Sundry Print Report

Well Name: NE SQ LAKE PREM Well Location: T16S / R31E / SEC 10 / County or Parish/State: EDDY /

Sundry ID: 2836182

Type of Action: Plug and Abandonment

North East Square Lake Premier Unit 21 Field: North East Square Lake Lease: NMNM04421 API #30-015-04837 10-16S-31E, Eddy County, NM 1980' FNL & 1980' FEL Tripp Oil & Gas

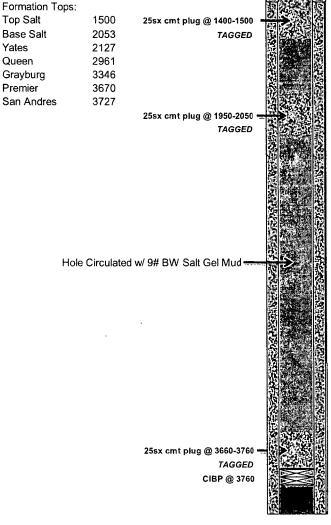
Created By	Condition	Condition Date
loren.diede	Notify the OCD inspection supervisor via email 24 hours prior to beginning Plug & Abandon (P&A) operations.	3/20/2025
loren.diede	A CBL is to be run after setting the CIBP at 3622'. Submit the CBL tif file to NMOCD for upload into the Well Log File.	3/20/2025
loren.diede	Please note: Plug depth revisions as noted by NMOCD conditional mapproval dated 11-16-2019.	3/20/2025
loren.diede	In addition to the NMOCD revised plug depths dated 11-16-2019; Add cement plugs as follows: Greyberg formation top, perf at 3396', squeeze cement to 3296', Queen formation top, perf at 3011', squeeze cement to 2911', Yates formation top, p[erf at 2177', squeeze cement to 2077'.	3/20/2025
loren.diede	This well is within the LPCH restricted area and a below ground marker is to be installed. Submit photo and GPS coordinates of the P&A marker with the subsequent P&A submission.	3/20/2025
